RFI #: 57  
 Date: 2/20/2012  
 Job: EB-02 Keller Springs Lofts  
 Phone: 877-777-5115

Subject: CMU Stair Towers Details

Project: Keller Springs Lofts  
 Addison, Texas  
 Project No.: 39155.1 Date: 02/29/2012 Drawing No.: SK-7

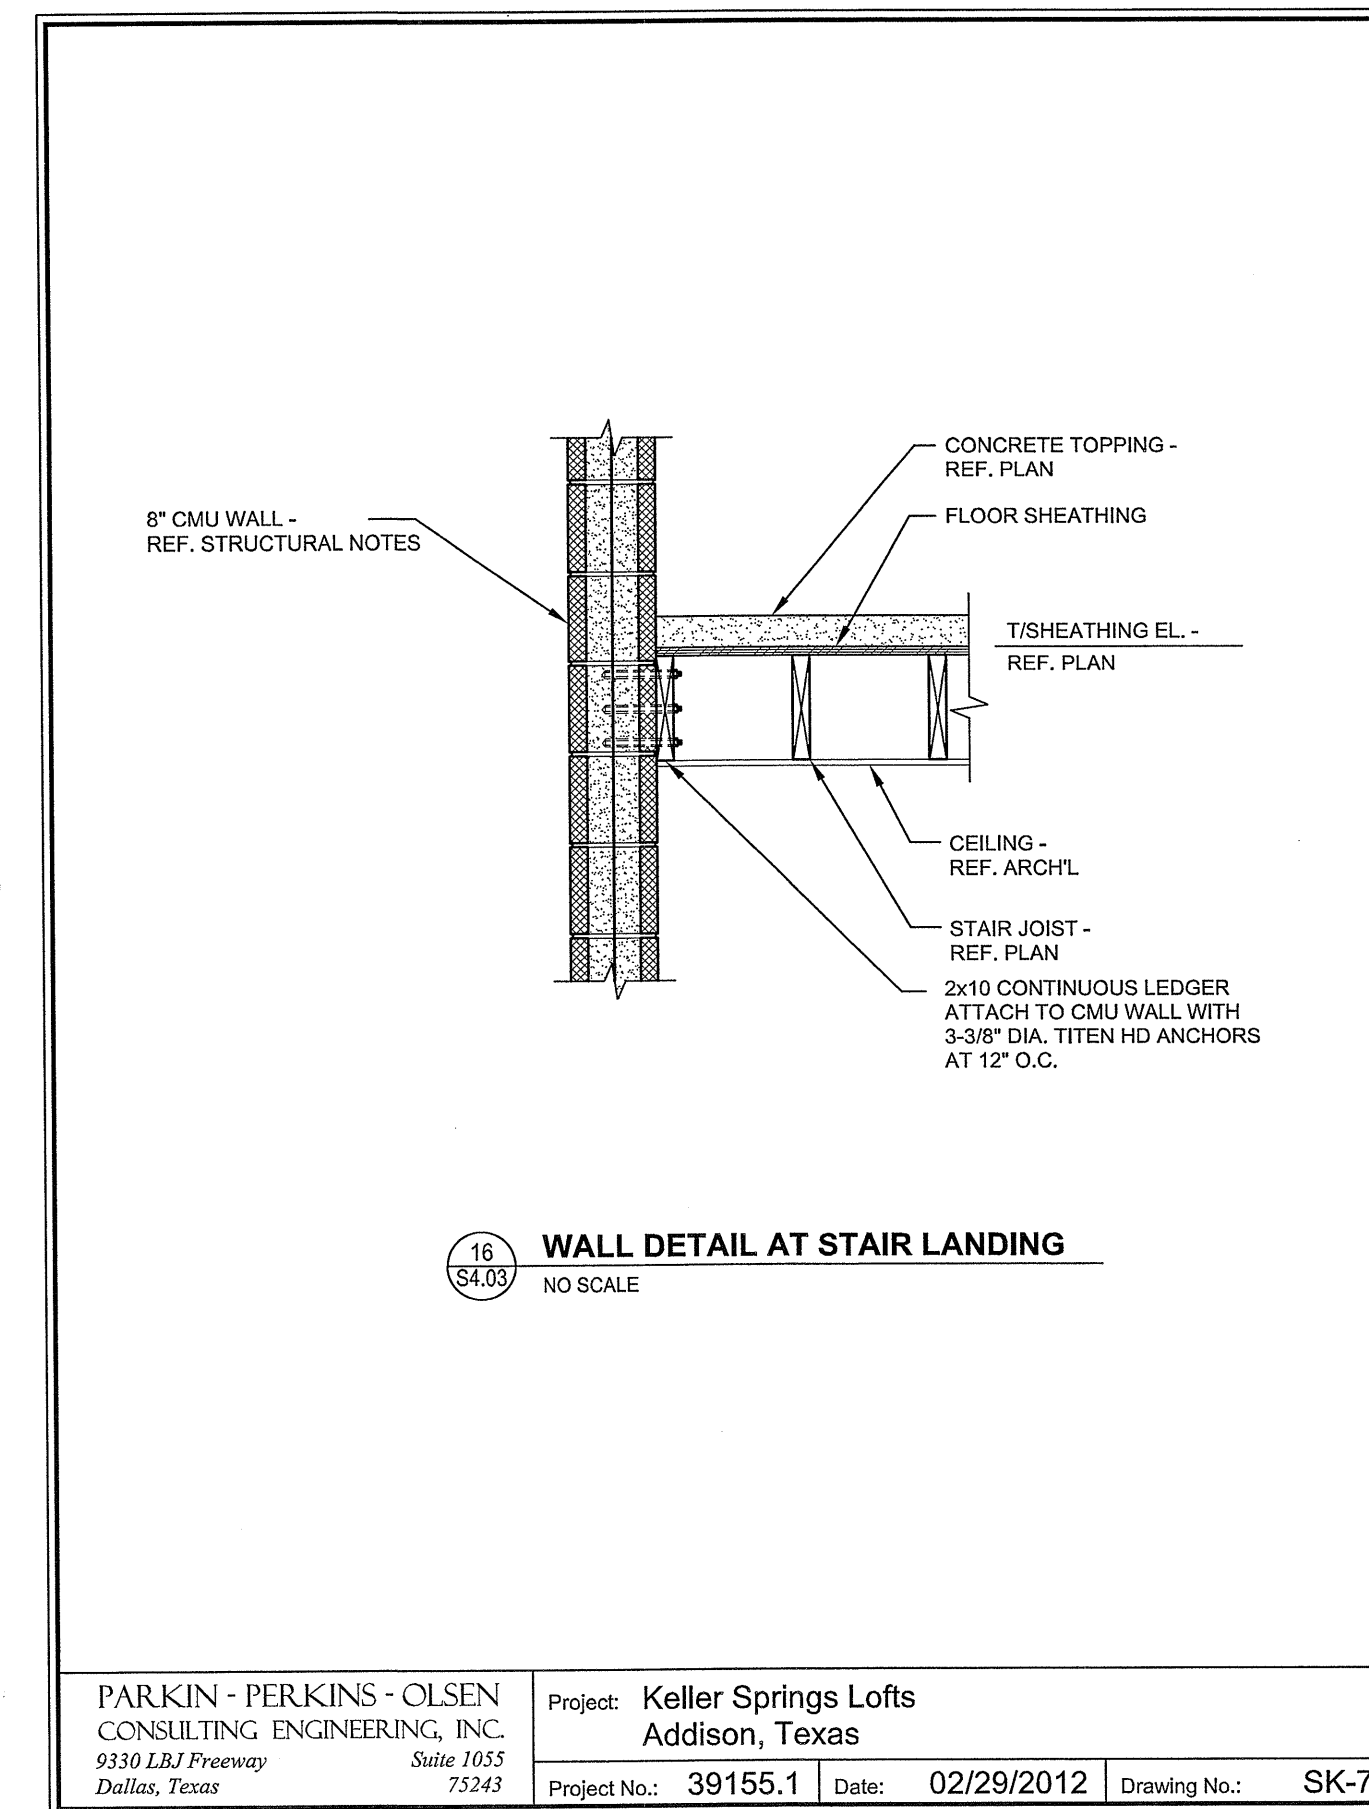
**Request:**  
 We have some questions concerning the CMU stair towers #4 & #5. (1) Page S2.24 has a cut through stairwell #4. This cut directs us to detail #6 on page S2.07. Detail #6 directs us to details #14 & #15 on page S4.02. These details (#14 & #15) are wood to wood connections. We will need a wood to CMU connection detail for this application. (2) I have not seen a detail for the window in CMU application. Will there be 2x framing in the window openings? We would also like to confirm that the landings in the 2 CMU stair towers are in fact wood. It has been our experience that the landings in these type assemblies are usually metal.

Landings at CMU stair towers are to be wood framed.  
 Please see attached details for attachment of 2x landing framing to CMU walls.

Wood beams at the that support the stair stringers shall be attached to the CMU wall with HU410 beam hanger fastened to CMU wall with 18-1/4x2 3/4" Titen HD anchors installed in accordance with the manufacturer's recommendations. All vertical cells in CMU walls at beam hangers shall be fully grouted over the height of the wall.
